Bayside Planning Panel

Item No	6.6
Application Type	Section 96(2) Application – Modification to semi-detached dwellings
Application Number	DA-16/116/02
Lodgement Date	28 August 2017
Property	124 Banksia Street, Botany Lot 2 in DP 308859
Owner	John and Matthew Hassarati
Applicant	Pinnacle Plus
Proposal	Section 96(2) Application to amend Development Consent No. 16/116 to reduce the size of the dwellings, delete the swimming pools and replace with a cabana at the rear of each dwelling
No. of Submissions	Nil
Cost of Development	N/A
Report by	Angela Lazaridis- Senior Development Assessment Officer

Planning Assessment Report

Application Number:	DA/16/116/02
Date of Receipt:	28 August 2017
Property:	124 Banksia Street Botany Lot 2 in DP 308859
Owner:	John and Matthew Hassarati
Applicant:	Pinnacle Plus
Proposal:	Section 96(2) Application to amend Development Consent No. 16/116 to reduce the size of the dwellings, delete the swimming pools and replace with a cabana at the rear of each dwelling
Recommendation:	Approval
Value:	N/A
No. of submissions:	Nil
Author:	Angela Lazaridis- Senior Development Assessment Officer
Date of Report:	8 November 2017

Figure 2. Proposed modification to the approved development

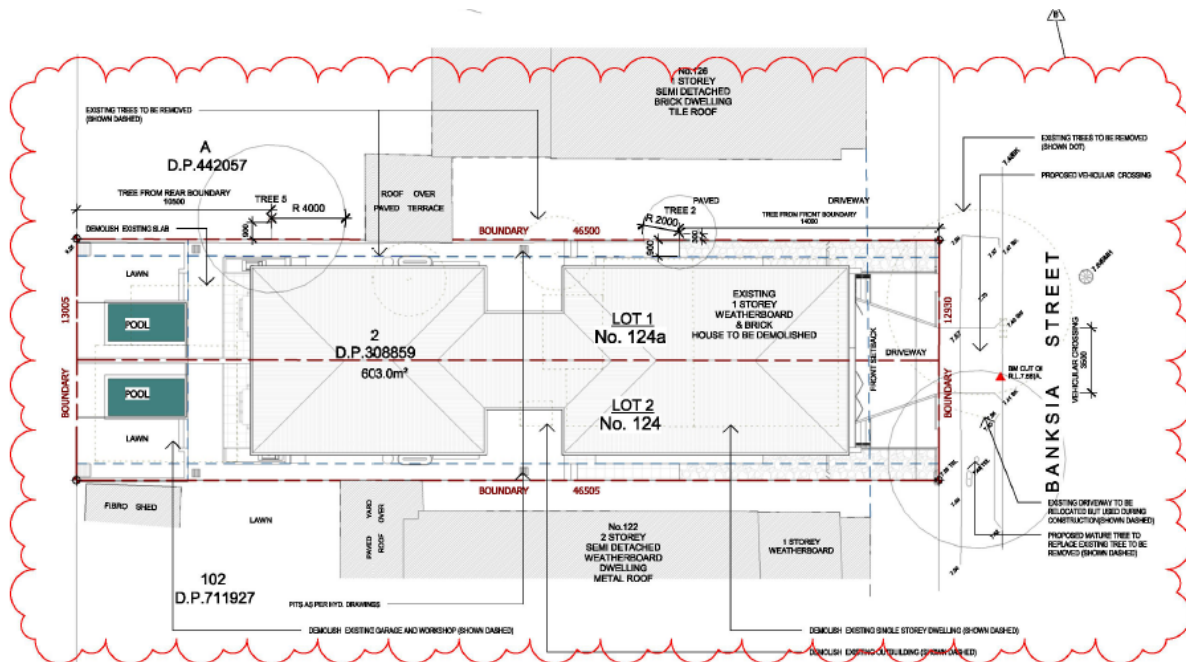
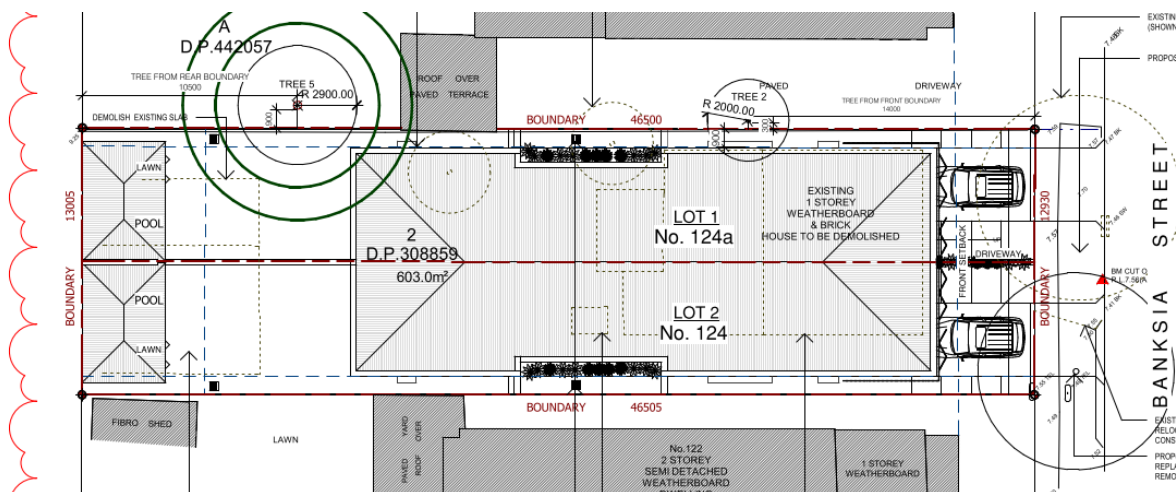
The Section 96(2) Application seeks consent to amend the approved semi-detached dwelling houses as follows:

- Reconfiguration of the approved dwelling houses to reduce the bulk of the dwellings by increasing the rear setback;
- Reduction in the height of the development from 8.4 metres to 7.2 metres and the roof is modified from a pitched roof to a predominantly flat roof;
- Removal of the approved swimming pools located within the rear yard and construction of individual cabanas on each site;
- Amendment to the front setback so that each dwelling has individual driveways and vehicular crossings;
- Removal of the skylights from the roof; and
- Removal of street tree on Council street verge.
